Van Waters & Rogers Inc.
subsidiary of **Univar**

June 30, 1994

As you are aware, Van Waters and Rogers Inc. (VW&R) is attempting to obtain a discharge permit for treated ground water generated at the Portland, Oregon facility. An NPDES Permit application, formally submitted to the State of Oregon for approval, was rejected over concerns raised by the City of Portland regarding the potential to have elevated levels of ammonia and cyanide in the effluent of the treatment system. It is our belief that this potential can be significantly reduced by locating the extraction wells exclusively along the western fence line. This will require a modification to the ICM work plan since two of the three proposed extraction wells were to be located adjacent to the rail spur, in the vicinity of SMW-6 and SMW-7.

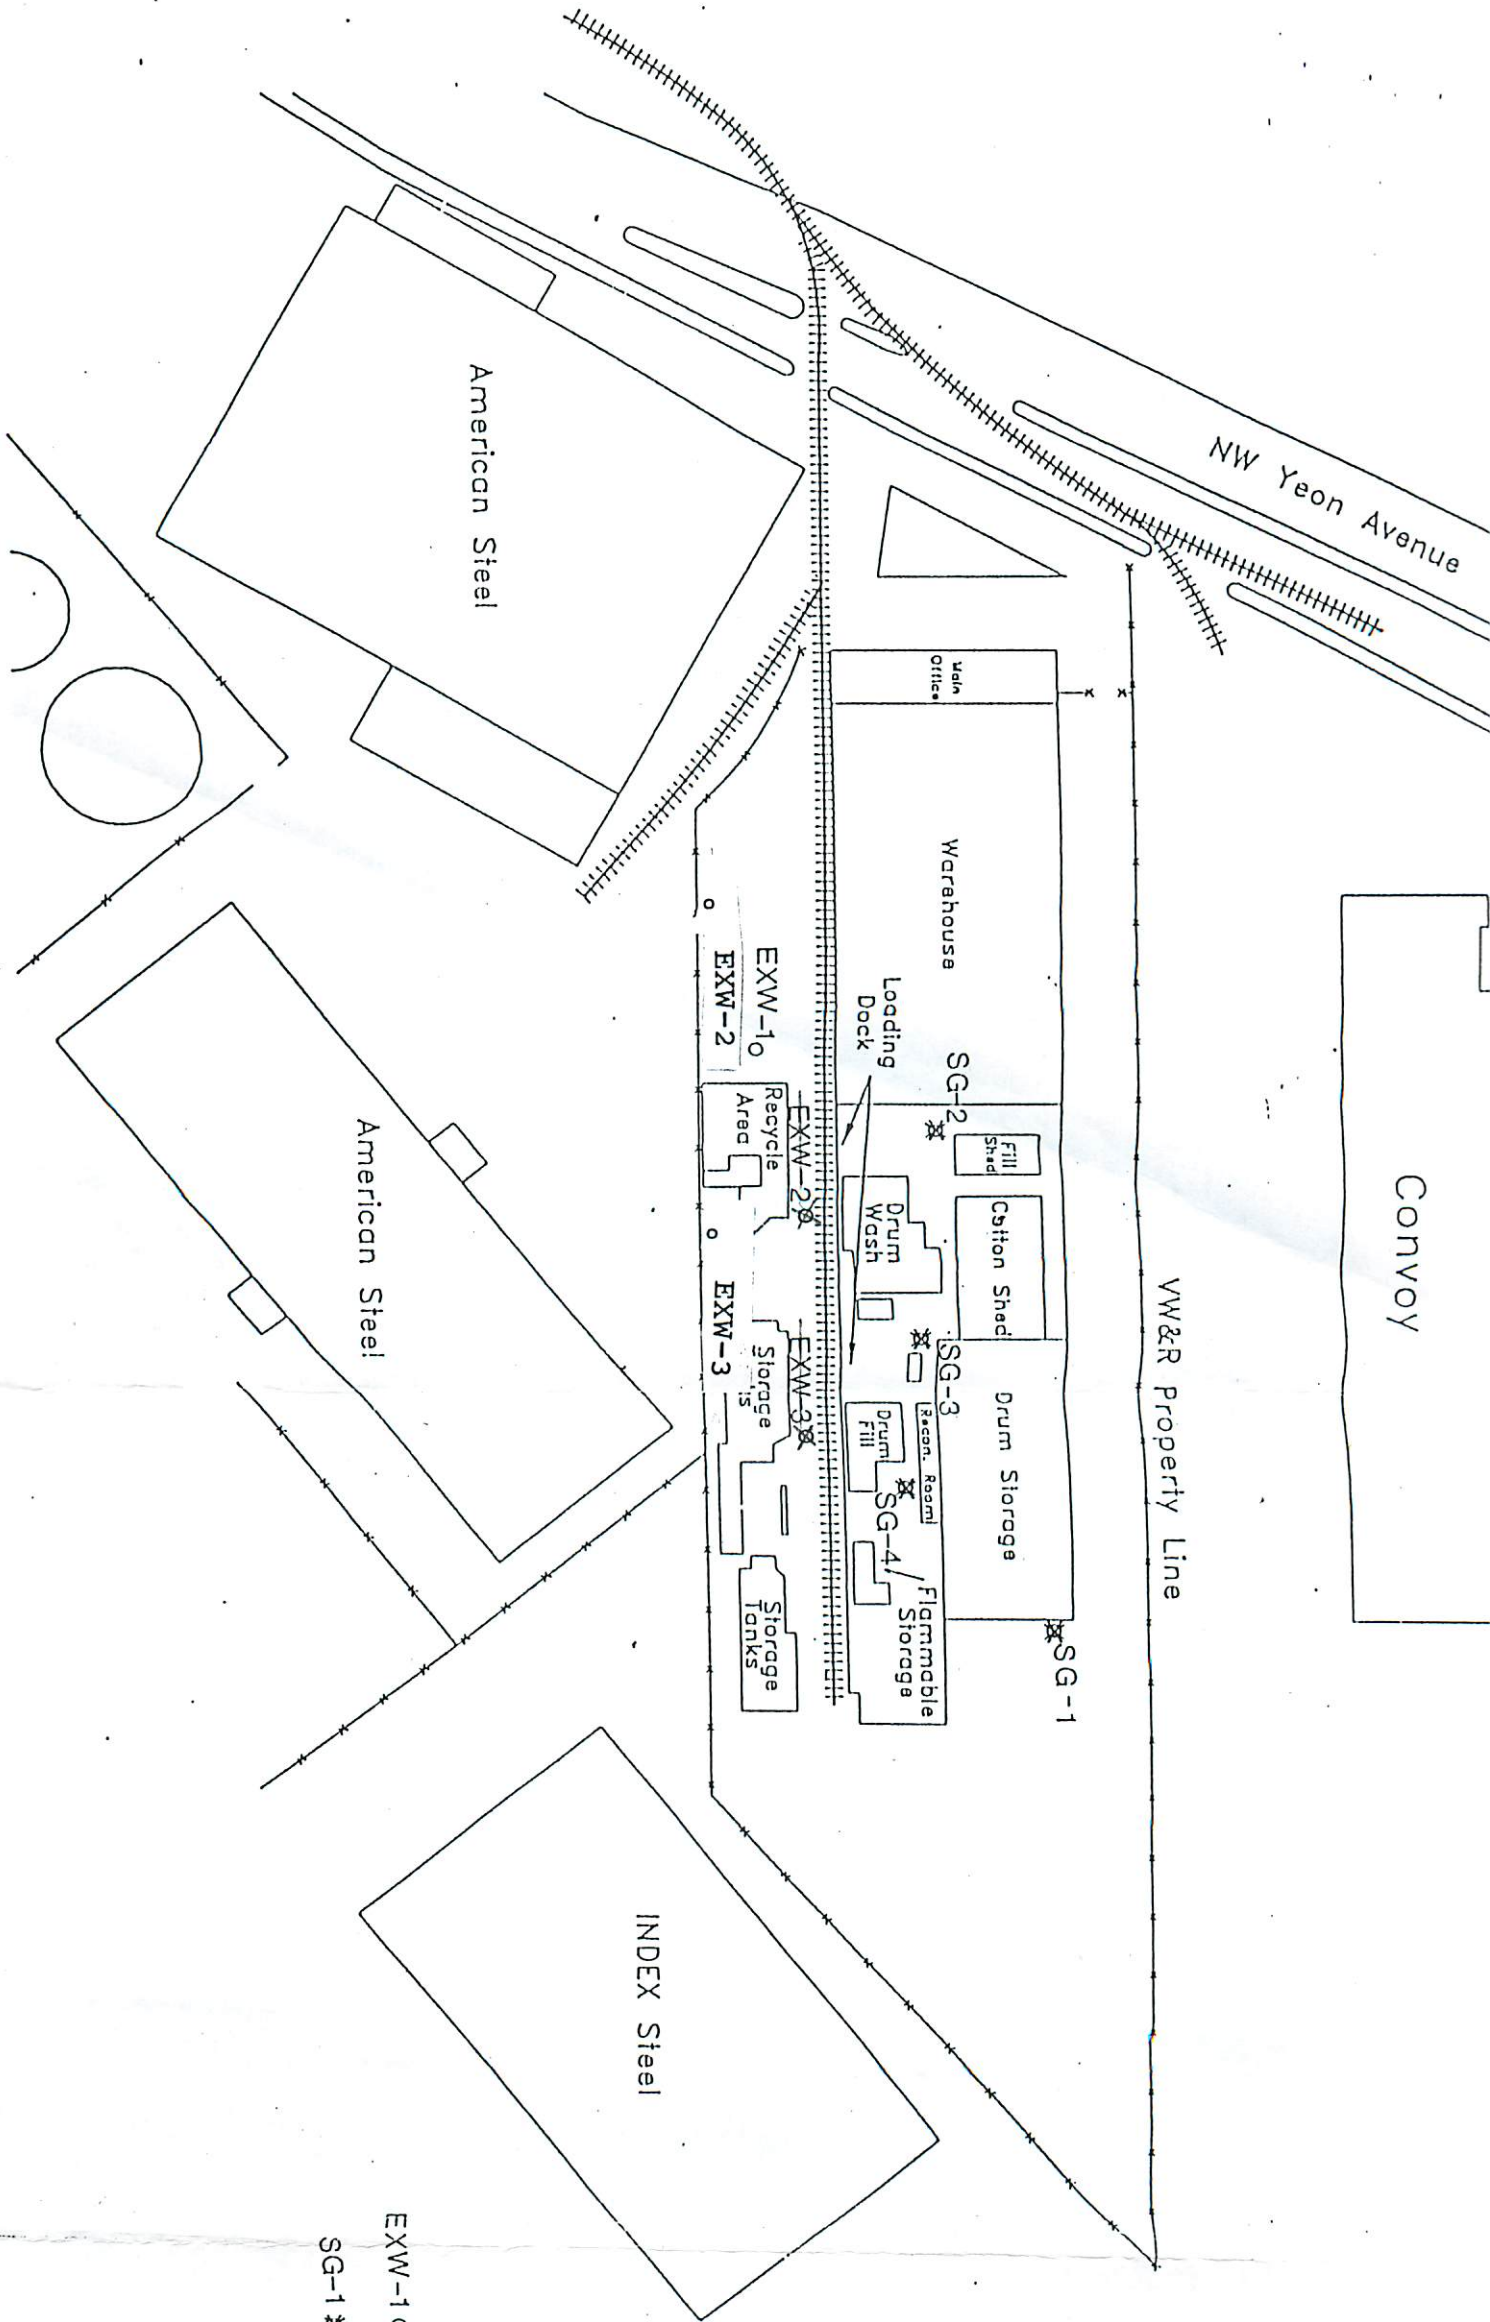
The phased approach for installation of the monitoring wells will remain as stated in the ICM work plan. The first extraction well (EXW-1) has been installed and is expected to commence operation within 45 days of approval of a discharge permit. This well will operate for approximately 90 days before the second phase is implemented. The two remaining ground water extraction wells will be installed in Phase II. It is anticipated that the second well will be operated for a period of 90 to 120 days before the third well is installed. These wells will be placed in areas of ground water contamination along the western fence line. Figure 1 (attached) shows the tentative locations for these wells, however the final locations will be based on the hydrologic parameters and operating performance of EXW-1 and upon the results of the most recent ground water analytical reports.
